**TOWN OF NEWBURGH
PLANNING BOARD
TECHNICAL REVIEW COMMENTS**

PROJECT: LAKESIDE SENIOR HOUSING
PROJECT NO.: 19-06
PROJECT LOCATION: SECTION 86, BLOCK 1, LOT 39.22 & 39.23
REVIEW DATE: 30 MAY 2019
MEETING DATE: 6 JUNE 2019
PROJECT REPRESENTATIVE: MAURI ARCHITECTS, P.C./ JAY DIESING, R.A.

**RE: Lakeside Senior Apartments
Town of Newburgh Project # 2019-06**

Revised Post Drainage Area Map

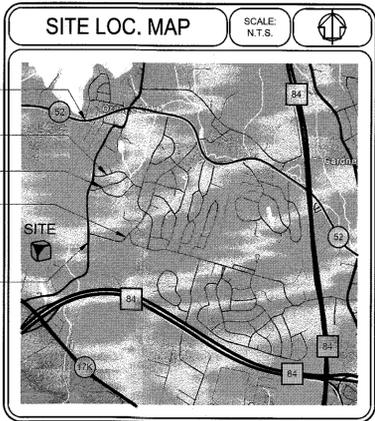
- 1. The project is before the Board to add a Clubhouse, pool, pavilion and recreational courts on the south side of the project. The Applicant's representatives are requested to evaluate potential impacts to the existing stormwater management facilities from the increased runoff. An existing bio-retention area exists immediately North of the proposed recreation facilities.*

The identified bio-retention area has been expanded for the increased run-off and the Site Plans and SWPPP have been amended to reflect the impact of the proposed Clubhouse and other facilities.
